## DEVELOPMENT REVIEW COMMITTEE (DRC) COMMENT REPORT

**PROJECT NAME:** Westin/Aura Cypress Creek

**CASE NUMBER:** UDP-PDD22003

**REQUEST:** Site Plan Level IV Review: Rezoning Request from Hotel (R-6 County) to Planned Development District (PDD) for 340 Multifamily Residential Units, 5,000 Square-Foot of Commercial Use, and Existing 298-Room Hotel

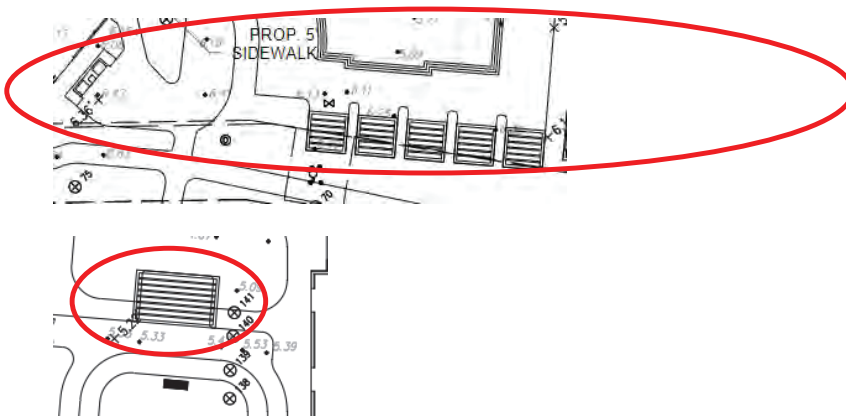
- 14) Provide the changes on the elevations and renderings:
- Dimension grade at crown of road, at curb, sidewalk, building entrance, and finished floor.
  - Add a variety of high quality materials to the facades of the mixed use building and parking garage.
  - Provide details and photographic examples for all materials including decorative fin, decorative aluminum screen, and garage screen as noted on Page A-3.00.
  - Add active uses lining the parking garage to enhance the public realm (especially at the highly visible corner of Cypress Creek Road and I-95 Corridor).
  - Add a vertical feature / framing along the eastern portion of northern facade, to better transition / break up the building mass. (See circled area on image below).
